Access Compliance Report

Public Rights-of-Way

(Curb Ramps)

Intersection ID: 31427	Main Street: CHEVIOTT_HILL_LN	Cross Street: RIDING_HILL_AV	Location: E
ADA ID: 751FCCD0FD36	Ramp Type: PerpDiag	Initial Pass/Fail: Fail	Overall Compliance: No
			Severity Score: 21.25

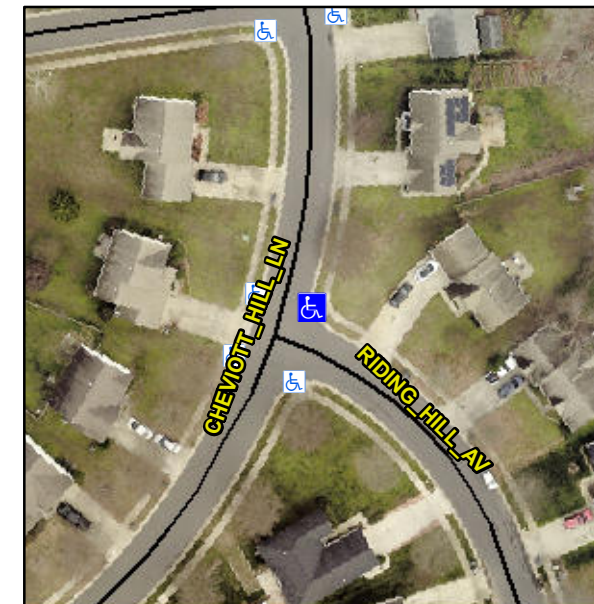
Not Found, R304.5.1, R304.2.2

Compliance	Description	Data	Compliance	Description	Data
N/A	Ramp Length (in)	48.0	No	Ramp Slope (%)	8.9
No	Ramp Width (in)	47.0	Yes	Ramp XSlope (%)	1.1
N/A	Flare Type LT	N/A	N/A	Flare Type RT	N/A
N/A	Flare Slope LT (%)	N/A	N/A	Flare Slope RT (%)	N/A
N/A	Flare Traversable LT?	N/A	N/A	Flare Traversable RT?	N/A
N/A	Landing Length (in)	N/A	N/A	DWS Provided?	N/A
N/A	Landing Width (in)	N/A	N/A	DWS Contrast?	N/A
N/A	Landing Slope (%)	N/A	N/A	DWS Length (in)	N/A
N/A	Landing X Slope (%)	N/A	N/A	DWS Full Width?	N/A
N/A	Landing Curb? (Y/N)	N/A	N/A	DWS Offset (in)	N/A
N/A	Shared Landing?	N/A			
N/A	Gutter Ponding?	N/A	N/A	Gutter Slope (%)	N/A
N/A	Gutter Lip Ht (in)	N/A	N/A	Gutter X Slope (%)	N/A
N/A	Painted X Walk1?	No	N/A	Painted X Walk2?	No
	X Walk 1 Direction	To NW		X Walk 2 Direction	To SW
N/A	X Walk 1 Width (in)	N/A	N/A	X Walk 2 Width (in)	N/A
	X Walk 1 Slope (%)	6.7		X Walk 2 Slope (%)	4.8
	X Walk 1 X Slope (%)	1.2		X Walk 2 X Slope (%)	2.2

Remove & Replace Curb Ramp With Two New Directional Ramps or Equivalent.
